Norwich to Tilbury

Document: 9.5 Proposed Change Application 1: Overview Report -
Change Request 1 (Bulphan) (CA1)

Final Issue CA1

March 2026

THE NATIONAL GRID (NORWICH TO TILBURY) ORDER
 PROPOSED CHANGE ORDER LIMIT PLANS - CHANGE REQUEST 1
 PROPOSED CHANGE TO THE PROJECT DESIGN
 REGULATION 5(2)(o)
 SECTION H (SHEET E, THURROCK COUNCIL)

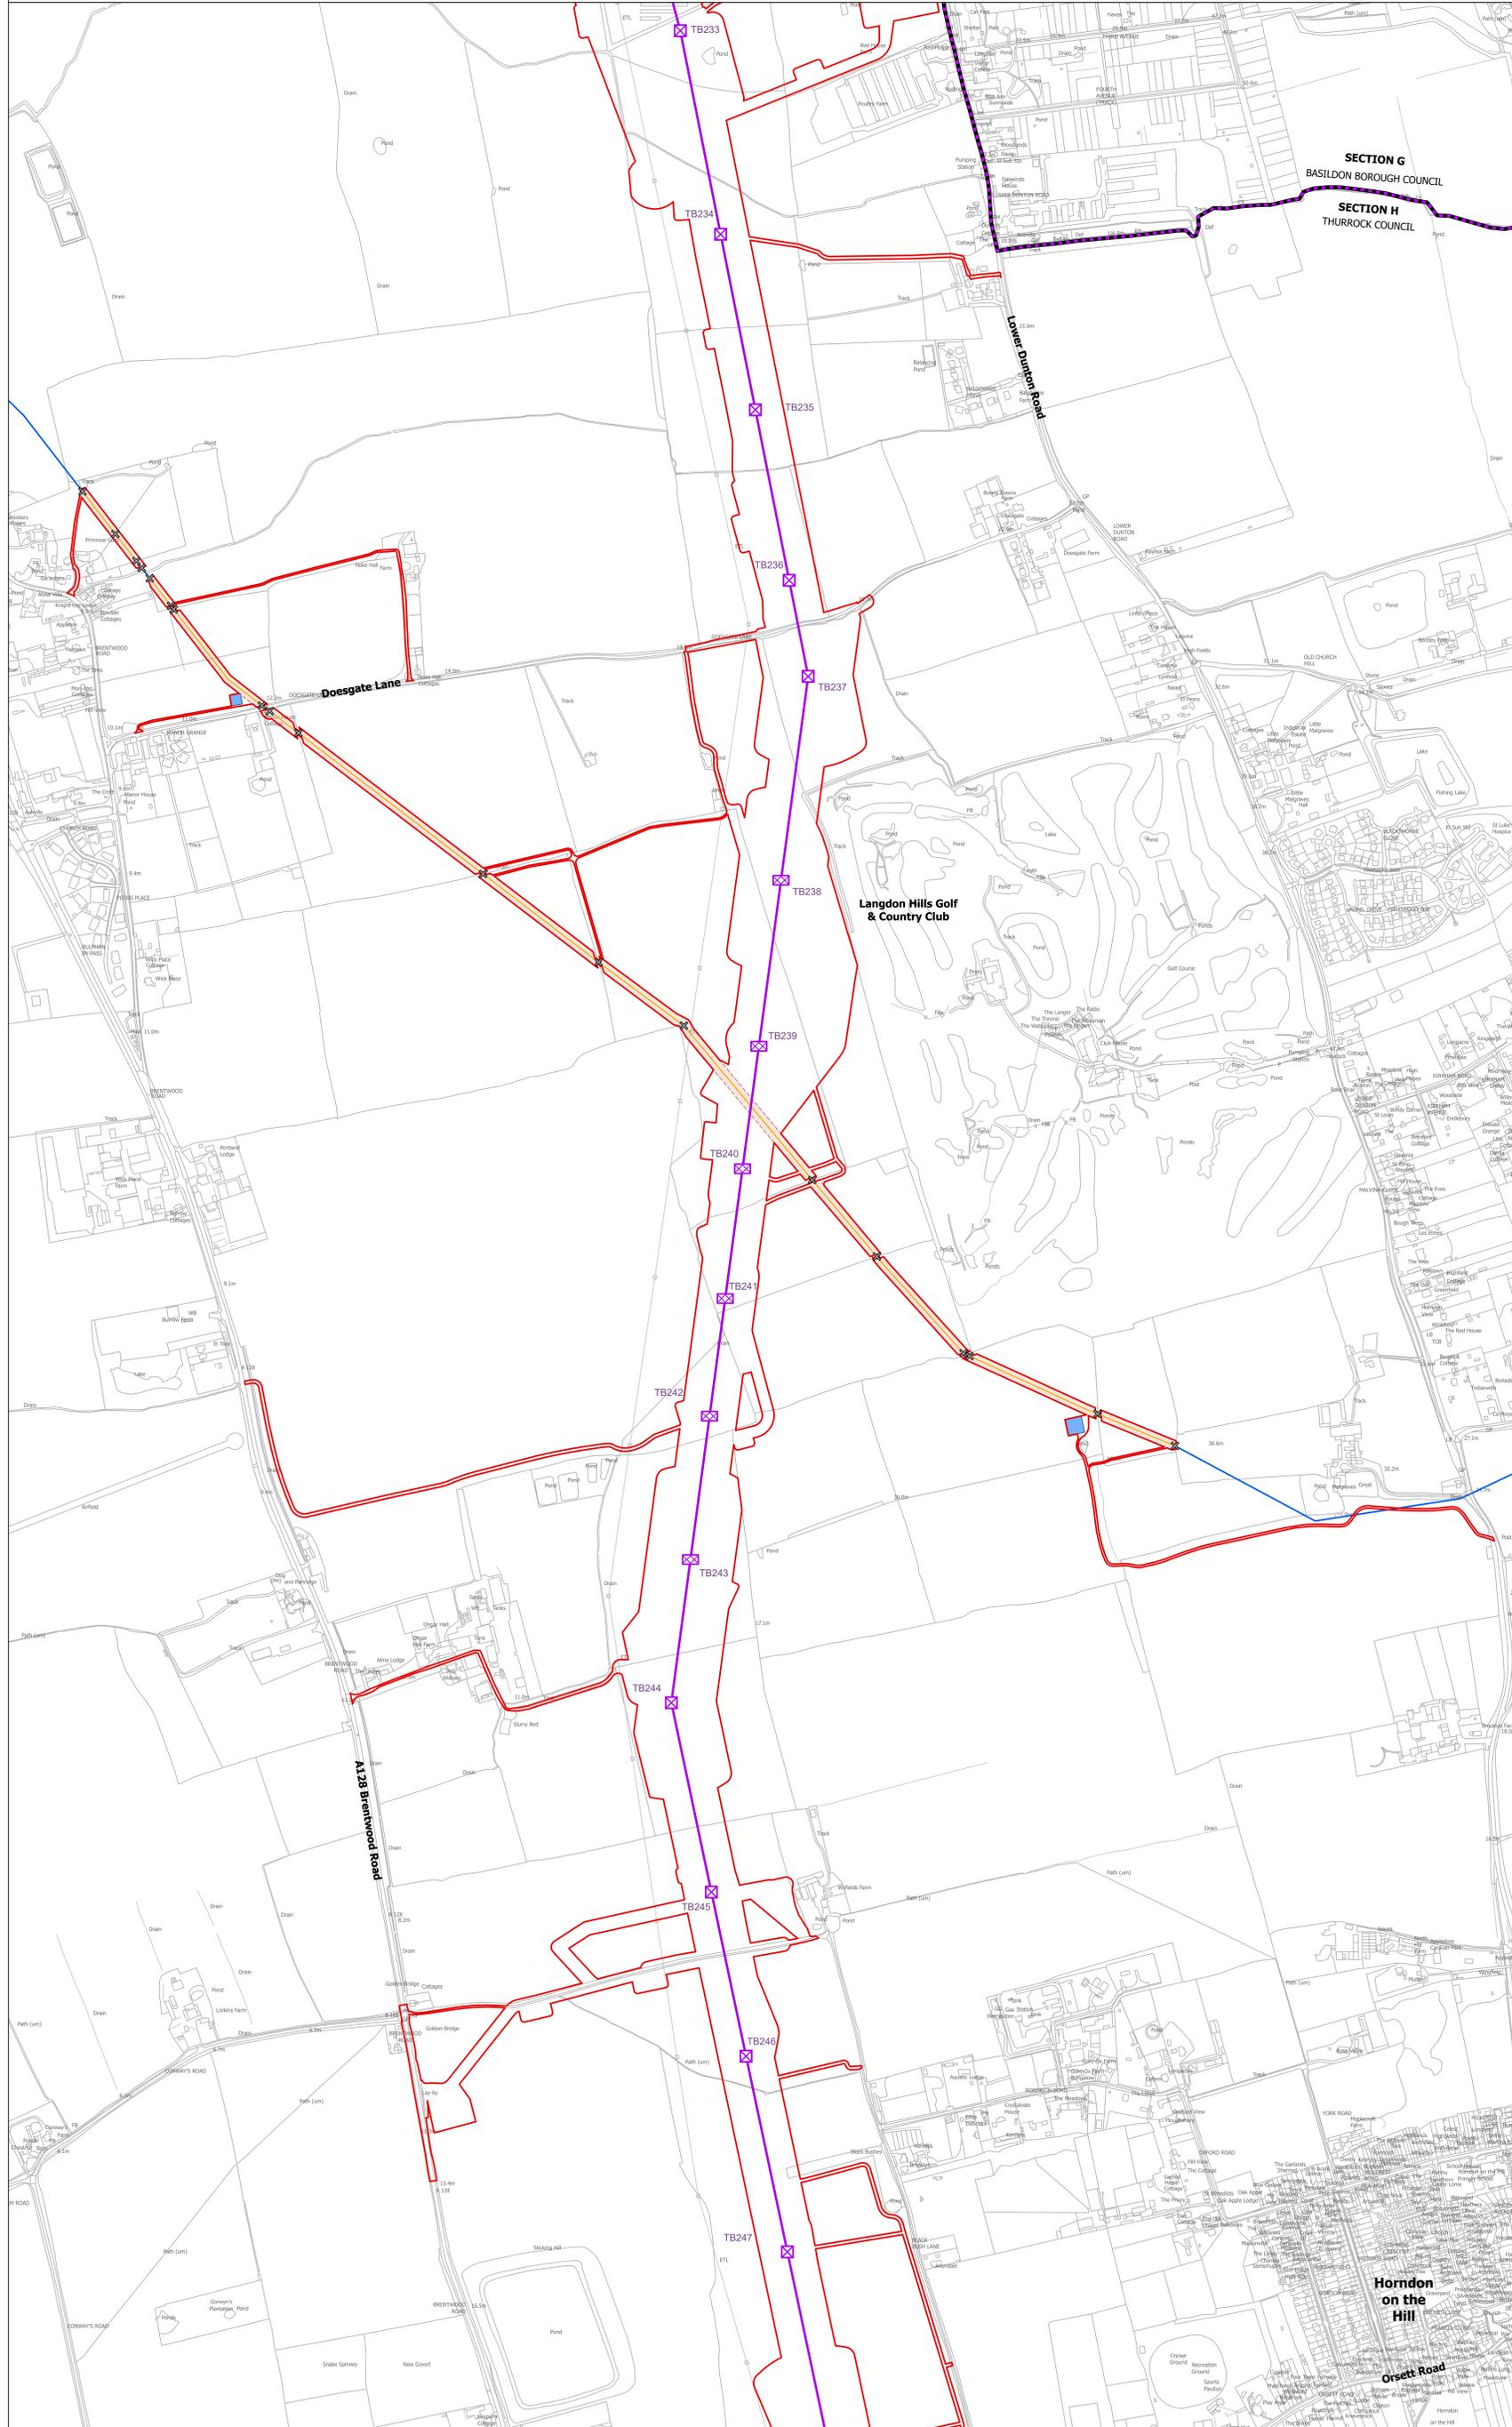
1.3.3 This document has been submitted to support Proposed Change Application 1 for Change Request 1 (Bulphan). Change Request 1 (Bulphan) relates to an increase in the Order Limits to facilitate works required for the protection of the existing Thames to Buncefield Multifuel Pipeline, west of Langdon Hills Golf Club. This proposed change responds to feedback concerning the potential for accelerated corrosion on existing buried metallic services received from the British Pipeline Agency Ltd (BPA) who act as the agent for the owner, United Kingdom Oil Pipelines Limited (UKOP). Further details about Change Request 1 (Bulphan) are provided in **Chapter 2** of this document.

- 2.1.3 Since submitting its application for development consent, the Applicant has continued engagement with the BPA as agent for UKOP (the owner of the Thames to Buncefield Multifuel Pipeline ('the Pipeline')). As a result of this engagement, the Applicant is proposing to incorporate a design change into the Project that seeks to address feedback raised by BPA in ongoing communication and within their Relevant Representation **[RR-0413]**. This design change is referred to as 'Change Request 1 (Bulphan)'. The change proposed applies to a very discrete geographical area of the Project and, as a consequence, the vast majority of the Project will remain entirely unchanged.
